Device **XC167CI-32F**
Marking/Step **(E)ES-BB, BB**
Package **PG-TQFP-144-7, P-TQFP-144-19**

This Errata Sheet describes the deviations from the current user documentation.

Current Documentation

Figure 1 Example for Case 2: Interrupt Service for Task C delayed

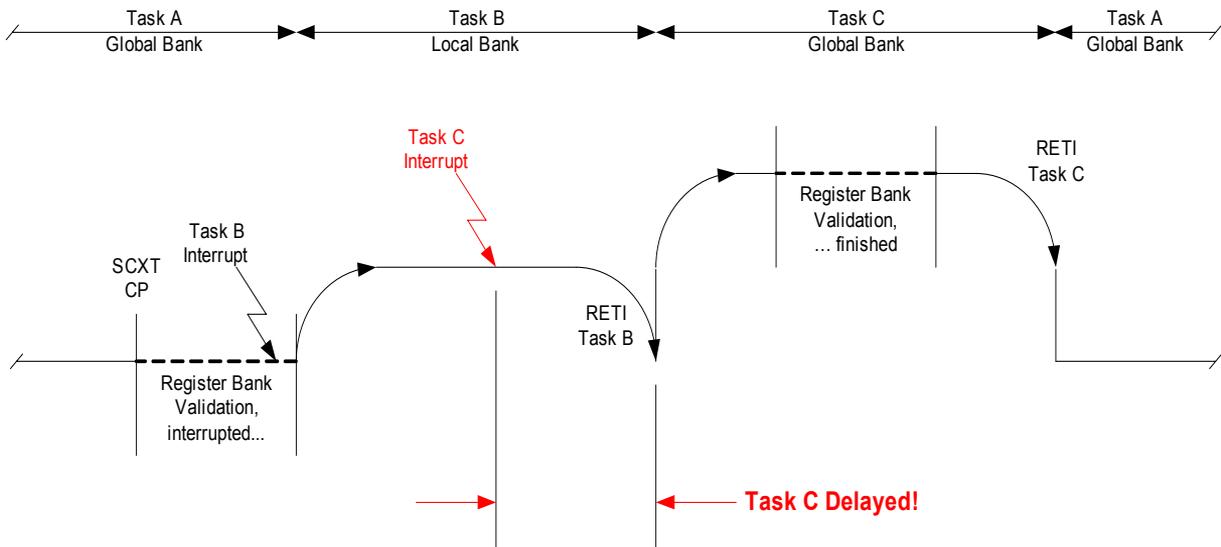
Case 2 (see also Figure 1):

- The Context Pointer CP is written to (e.g. by POP, MOV, SCXT .. instructions) within a routine (Task A) that uses a **global** register bank (bit field PSW.BANK = 00_B), i.e. the context for this routine will be modified,
- This context switch procedure (19 cycles) is interrupted by an interrupt request (Task B) which is programmed (with GPRSELx = 1X_B) to automatically use one of the **local** banks via the bank selection registers BNKSEL0..3 (i.e. the interrupting routine has a priority level ≥ 12),
- Before the corresponding interrupt service routine is finished, another interrupt request (Task C) occurs which is programmed (with GPRSELx = 00_B) to automatically use the **global** bank via the bank selection registers BNKSEL0..3 (i.e. the interrupting routine has a priority level ≥ 13).

In this case service of this interrupt request (for Task C) is delayed until bit field PSW.BANK becomes 00_B after executing the RETI instruction at the end of the routine (Task B) using the local bank.

Workaround for Case 2

When using both local and global register banks via the bank selection registers BNKSEL0..3 for interrupts on levels ≥ 12 , ensure that there is no interrupt using a global register bank that has a higher priority than an interrupt using a local register bank.
